STAFF REPORT: 7/10/2024 MEETING **ADDRESS: 1628 LEVERETTE** APPLICATION NO: #HDC 2024-00113 HISTORIC DISTRICT: CORKTOWN **APPLICANT: ALEXANDER BELILOVSKI** DATE OF STAFF SITE VISIT: 6/25/2024 DATE OF PROVISIONALLY COMPLETE APPLICATION: (NOT COMPLETE)

### **SCOPE:** REHABILITATE EXTERIOR

1628 Leverette, current conditions facing northeast. Staff photo taken 6/25/2024

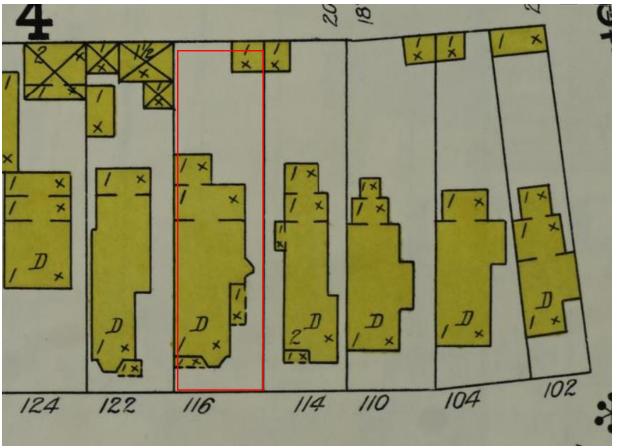
The resource located at 1628 Leverette is a one-story- single family home that was erected ca. 1880. The building features a cross-gabled roof main/central mass with lower, rear gabled-roof wings. A shed-type porch roof on wood posts has recently been added to a partial width porch at the building's east wall. Asphalt shingles and new wood fascia board have recently been installed at the roof. All exterior siding has also been removed from the front façade and the south portion/half of the west wall. The original, lapped wood siding remains at the rear half of the west wall, the east wall, and the rear. A bay window at the front façade appears to have been recently rebuilt, while the historic bay at the east wall's porch area appears to remain intact, albeit damaged by a recent fire. All exterior doors and a number of window units are missing in their entirety/to the rough opening, to include sash and trim/casing. Remaining windows appear to be wood-double hung units.

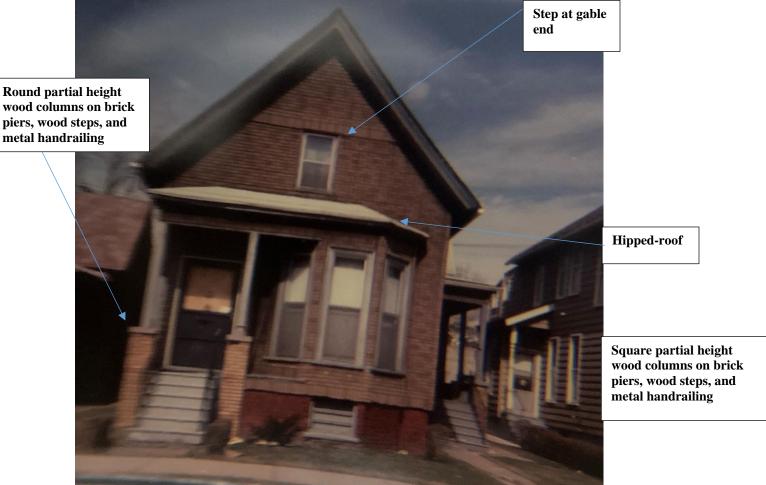
Per the submitted drawings and narrative, the applicant is seeking the Commission's approval of the following work items:

- Build a new partial-width, shed roof wood porch at front façade
- Build a new partial-width, shed roof wood porch at east side (work initiated)
- Rebuild a canted bay window at the front façade (work initiated)
- Remove all siding (work initiated) and replace with new cement fiber lapped siding
- Replace all existing windows with new, double-hung, aluminum-clad wood units (work initiated). The windows will have a 1/1 light configuration
- At roof, replace existing asphalt shingle with new asphalt shingles (work completed), existing fascia with new fascia board (work completed), and install new aluminum gutters and downspouts
- Install new exterior doors
